175	02/23/11	CO #147
458	02/27/12	CO #337
458	03/16/12	ASI #190

ADDITIONAL NOTES FOR INSTALLATION OF METAL SUSPENSION CEILING SYSTEM PER OSHPD RESOLUTION TO COMPLY WITH CBC SECTION 1614A.1.1 AND 809.1.

A11.10.2

COMPLY WITH CBC 2007 SECTIONS 1614A.1, 9803.9.1.1 & 2506.2.1, ACSE07 SECTION 13 & IR 25-5 REQUIREMENTS FOR SUSPENDED CEILINGS.

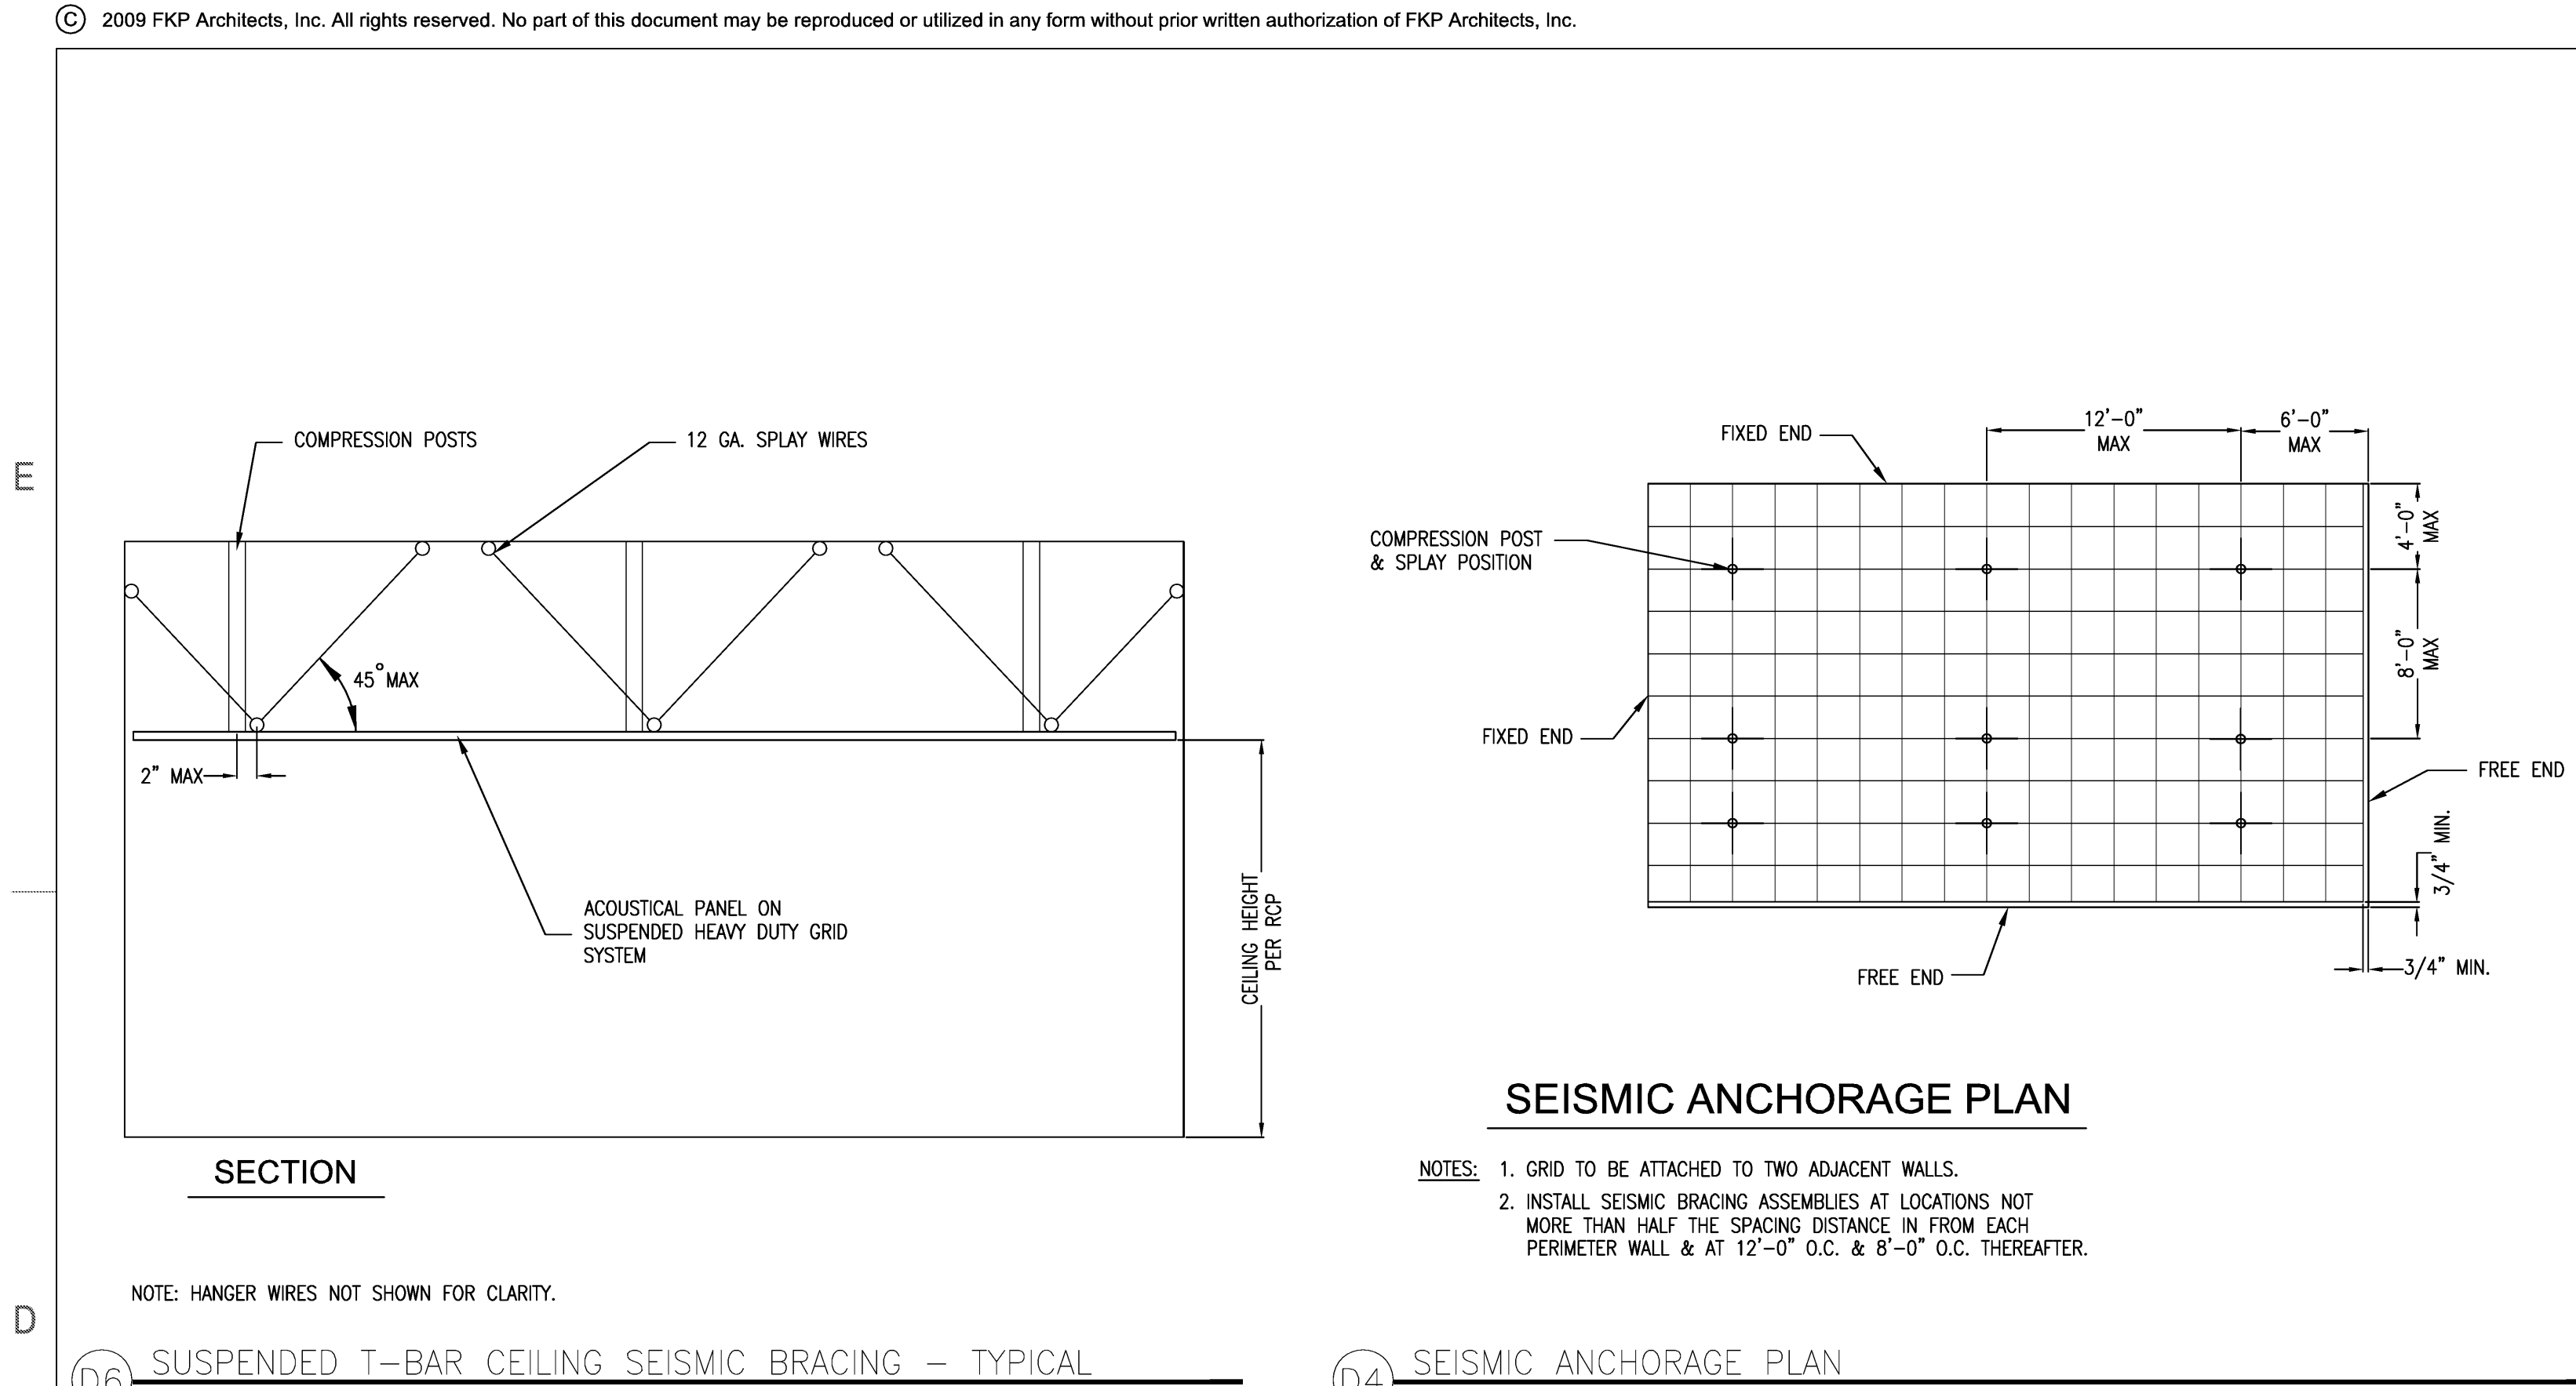
- WHERE CEILING GRID HAS NOT YET BEEN INSTALLED IN EXITWAYS:
 - USE DETAIL C4/A11.10.2
- FOR CEILING GRID IN EXITWAYS WHERE BERC CLIPS HAVE BEEN INSTALLED:
 - USE DETAIL B4 & B6/A11.10.2
 - VERTICAL HANGER WIRES WILL BE ADDED TO THE RUNNERS PERPENDICULAR TO THE WALL ANGLE FOR BOTH FIXED AND SLIP END AS REQUIRED ON A CASE-BY-CASE BASIS VERIFIED BY THE IOR, SEOR AND AOR.
